## MANUAL IDENTIFICATION

Model Number: 8445B

Part Number: 08445-90103

This supplement contains important information for correcting manual errors and for adapting the manual to instruments containing improvements made after the printing of the manual.

Figure 1. Partial Schematic of Figure 8-10

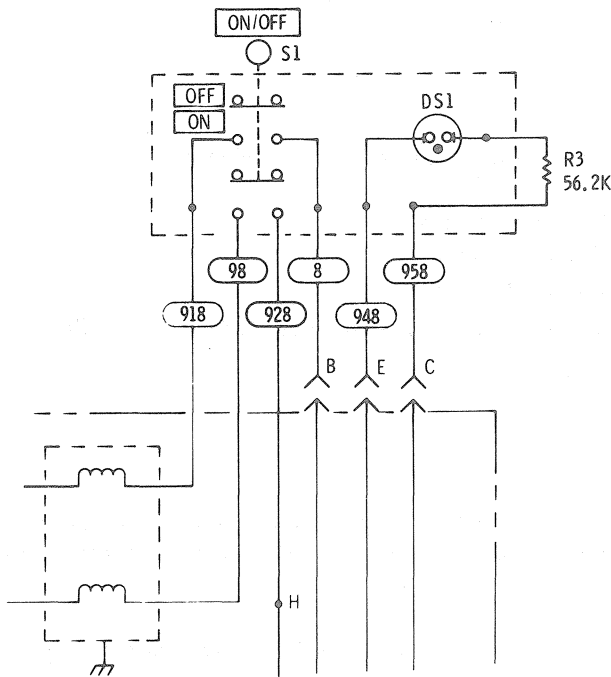
Page 8-23, Figure 8-10 (Service Sheet 6):

Change the diagram as shown in the partial schematic of Figure 1.

Figure 2. Partial Schematic of Figure 8-9. (P/O Change 1)

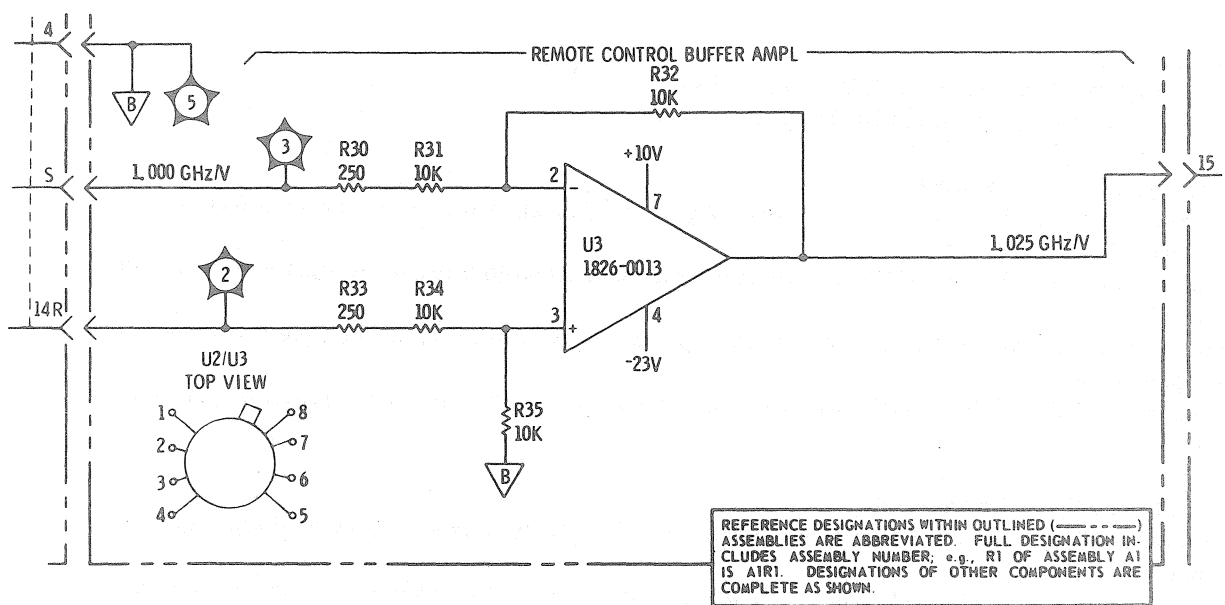
Page 8-9, Figure 8-21 (Service Sheet 5):

Change the circuit diagram as shown in the partial schematic Figure 2.

Figure 3. Partial Schematic of Figure 8-8. (P/O Change 2)

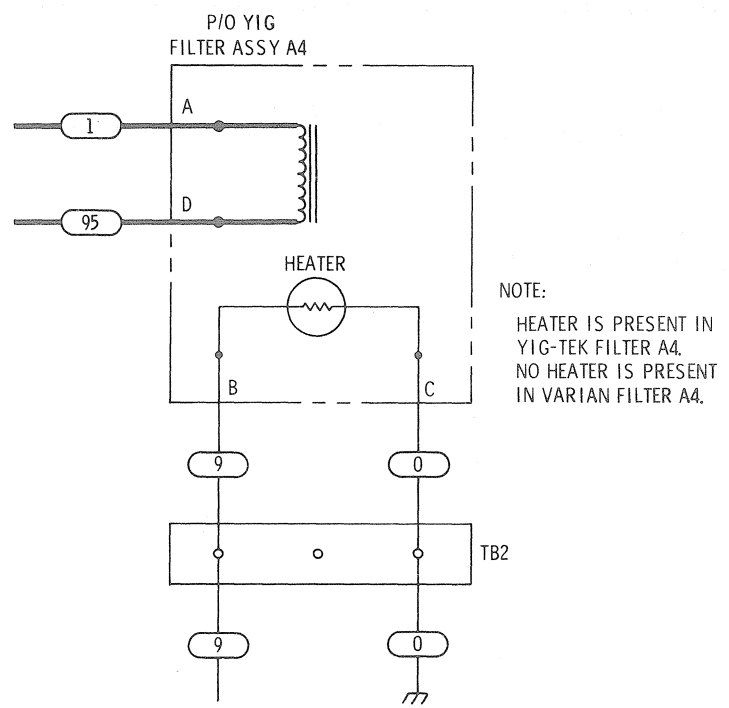
Page 8-19, Figure 8-8 (Service Sheet 4)

Add terminal strip TB2 as shown in partial schematic Figure 3.

Figure 4. Partial Schematic of Figure 8-10. (P/O Change 5)

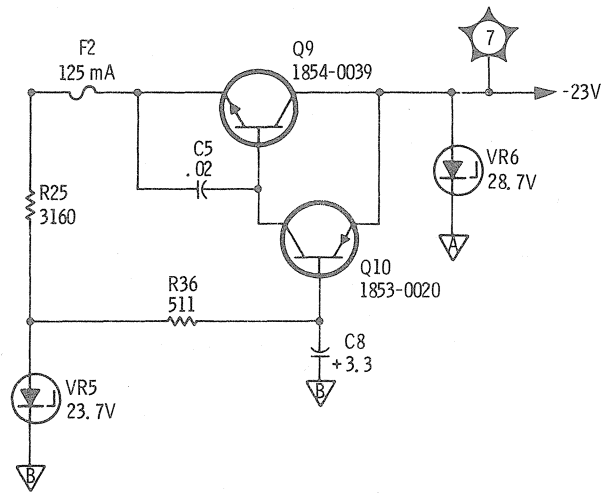
**Page 8-23, Figure 8-10, Service Sheet 6:**

Add A2R36 and A2C8 as shown in partial schematic Figure 4.
